**SNOWY 2.0 TRANSMISSION
CONNECTION PROJECT**

Independent Environmental Audit
Construction Audit 3

July 2025

Prepared by
Umwelt (Australia) Pty Limited
on behalf of
Transgrid

Figure 1 Average mulch cover and sample plot post clearing VI score (LENECO, 2025)

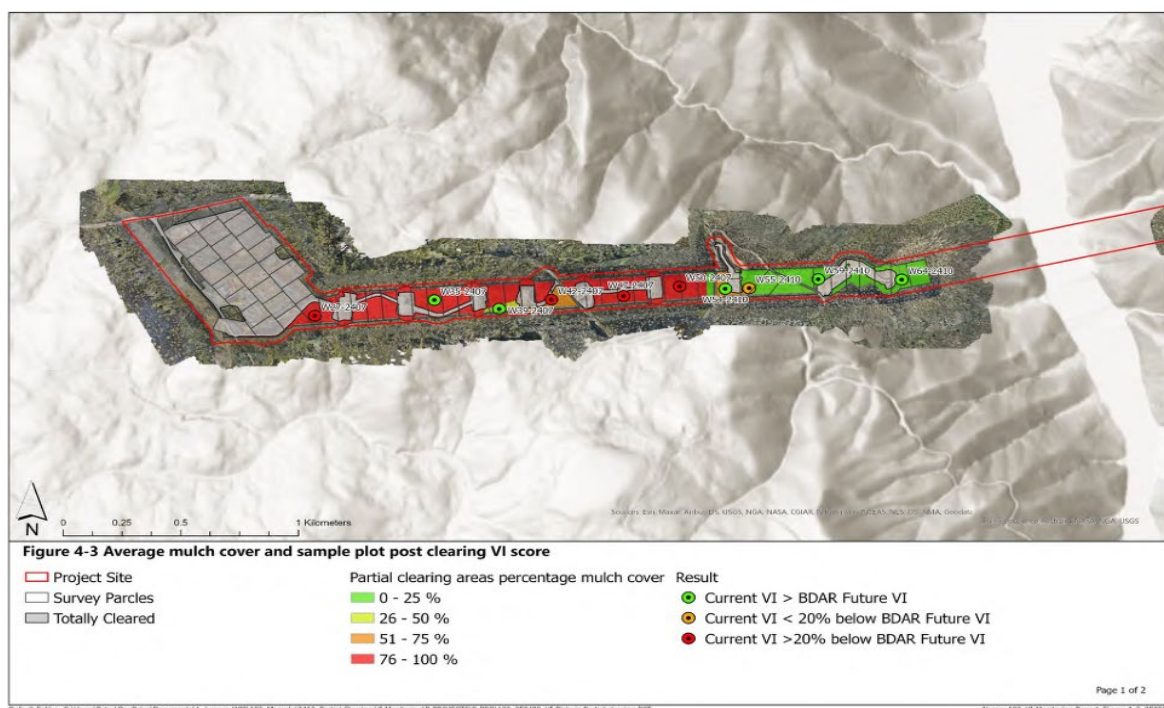
Within the Easement Clearing Zone (ECZ) on the Project West between the Maragle Switch Yard and Track 1 over an area of approximately 1.5km of the easement, significant groundcover disturbance was observed (refer to **Plate 8**, **Plate 9**, **Plate 10**, **Plate 11**, **Plate 12**, **Plate 13**, **Plate 14**, **Plate 15**, **Plate 16**, **Plate 17** and **Plate 18** in **Appendix 5**). Specifically, the retention of managed shrub and groundcover vegetation appeared to be compromised due to the use of extensive application of woodchip mulch, particularly between the western extent of the Project Area, west from Track 1. This excessive generation and application of mulch is considered to be attributed to failure to adhere to the BMP clearing requirements, which required an excavator mulcher to be utilised for clearing of trees with a diameter under 200 mm. After the site inspection, a Post-clearing Vegetation Integrity Monitoring Report (LENECO April 2025) was provided. The report identified that from February to May 2024, clearing in the ECZ was undertaken using an excavator-mounted mulcher, with Transgrid noting that a forestry mulcher was also utilised for a period in March 2024 however after March was no longer used due to challenges with steeper/undulating terrain. As observed during the audit site inspection the use of these clearing methods has resulted in excessive woodchip mulch and increased ground disturbance, especially in the taller forest areas in Project Area West. The LENECO Report also identified this and mapped an area of approximately 1.5km between Maragle Switch Yard and Track 1 where mulch cover was confirmed to range from 76% to 100% (refer to **Figure 1**). The use of the forestry mulcher on the Project West site did not comply with the BMP's requirement to use a excavator mulcher. The forestry mulcher is not considered a similar machine to an excavator mulcher due to differences in design, mobility, and application. Forestry mulchers are self-propelled, purpose-built machines designed primarily for clearing on-ground vegetation, shrubs, and small trees over large areas, whereas excavator mulchers are attachments fitted to excavators, offering greater flexibility for selective clearing, especially in partial clearing zones.

This non-compliance has likely led to increased disturbance and impacts to shrubs and ground cover vegetation and resulted in excessive woodchip cover that has smothered shrub and groundcover vegetation that was required to be retained. Furthermore, the application of mulch at such depth has likely elevated ground temperatures, potentially degrading the soil seedbank. It is important to note that spreading mulch is not considered a form of rehabilitation and, in this case, may have had the opposite effect by impeding vegetation recovery. The extent of the impacts observed from this have the potential to have resulted in environmental harm (as defined under the Infrastructure Approval).

Plate 25: Track 4 Sediment trap, evidence of soil binder present however outlet is unlined (Inspection Date: 12/03/2025).

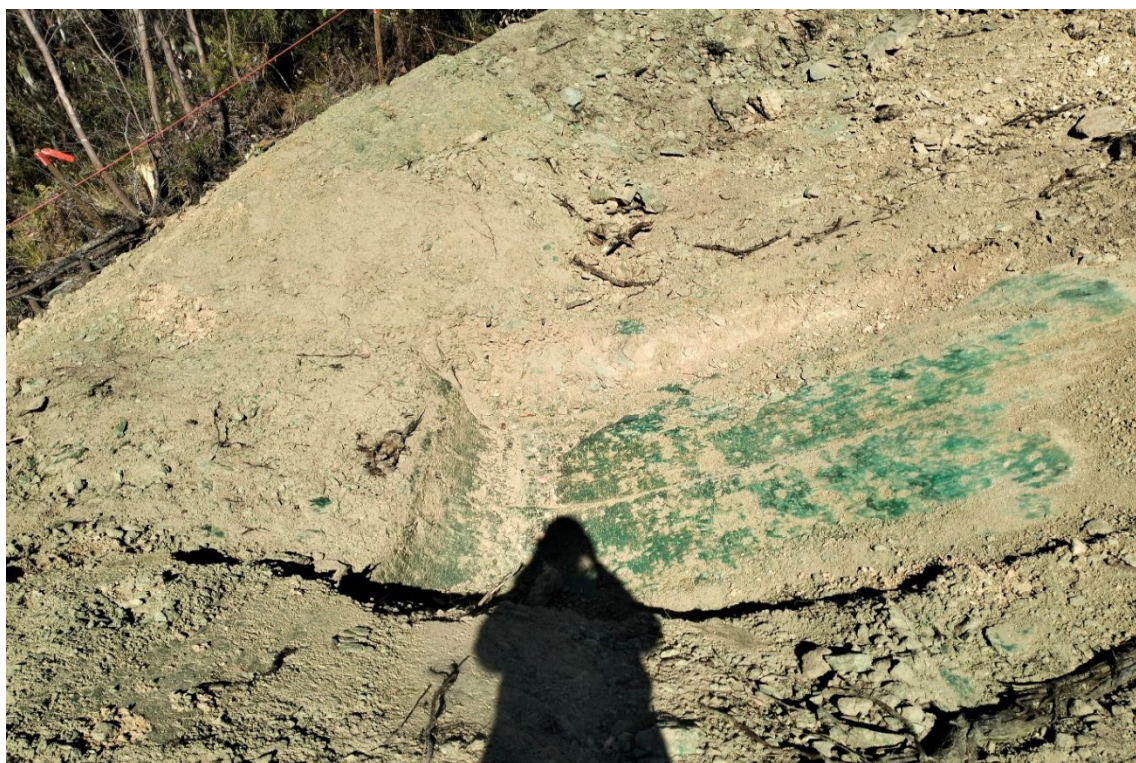
Plate 26: Track 4 Sediment trap, evidence of soil binder present however outlet is unlined (Inspection Date: 12/03/2025).
